RFQ NUMBER
DEFK8021

ADDENDUM #5

ISSUE DATE: August 31, 2007

PROJECT: MOUNTAINEER CHALLENGE ACADEMY
Camp Dawson
Kingwood, West Virginia

Project number	2006.06.00
Date	August 31, 2007
A103A	FIRST FLOOR PLAN - PART A

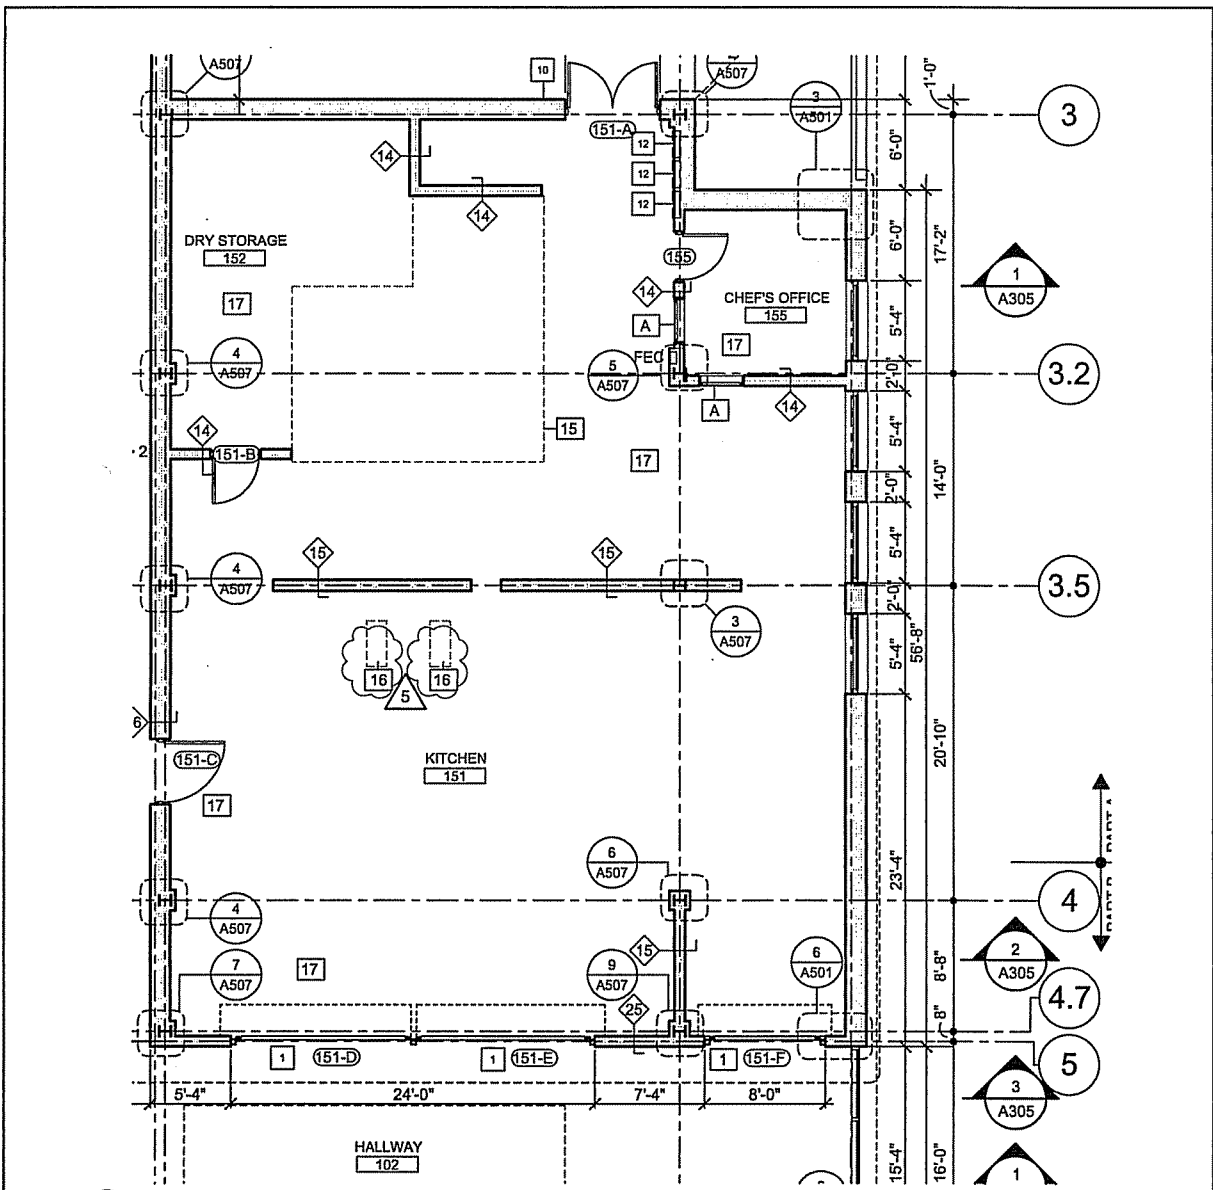
05-05: A103A FIRST FLOOR PLAN – PART A: General Notes, Revise note #8, note # 15 and # 16, Add note #17, Revise note #16 location on floor plan, all as indicated on SD-03, attached.

- 16 RECESSED SLAB AT FLOOR TROUGH. COORDINATE LOCATION DEPTH AND CONNECTIONS WITH FOOD SERVICE EQUIPMENT SUPPLIER PRIOR TO FLOOR SLAB INSTALLATION.
- 17 RECESSED SLAB AT QUARRY TILE FLOOR FINISH BY 1/2" TO PROVIDE FLUSH FINISH WITH ADJACENT HALLWAY FINISH. VERIFY FLOOR FINISH MATERIAL THICKNESS FOR FINAL INSTALLATION WITH SUPPLIER, PRIOR TO SLAB INSTALLATION.
